Charging Limit Setting Defaults to Full After Every Key Cycle

Service Category Engine/Hybrid System

Section Hybrid/Battery Control System

YEAR(S)	MODEL(S)	ADDITIONAL INFORMATION
2024	RZ300E, RZ450E	VDS(s): AAAAB, ABABB

Figure 1.

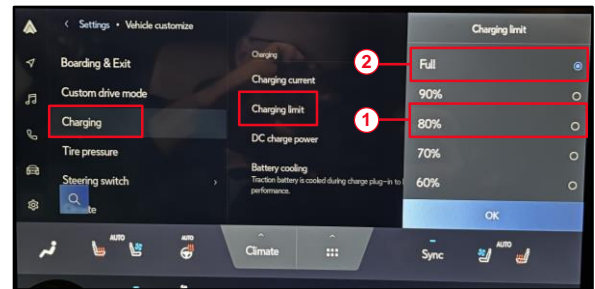
1. Confirm the condition exists.
 - A. Go to *Settings – Charging – Charging limit*.
 - B. Select 80%.
 - C. Ready OFF.
 - D. Wait three minutes.
 - E. Ready ON.
 - F. Go back to *Settings – Charging – Charging limit*.

Did the charging limit setting default to Full after the key cycle?

- **YES** — Continue to step 2.
- **NO** — This bulletin does NOT apply. Continue diagnosis using the applicable Repair Manual.
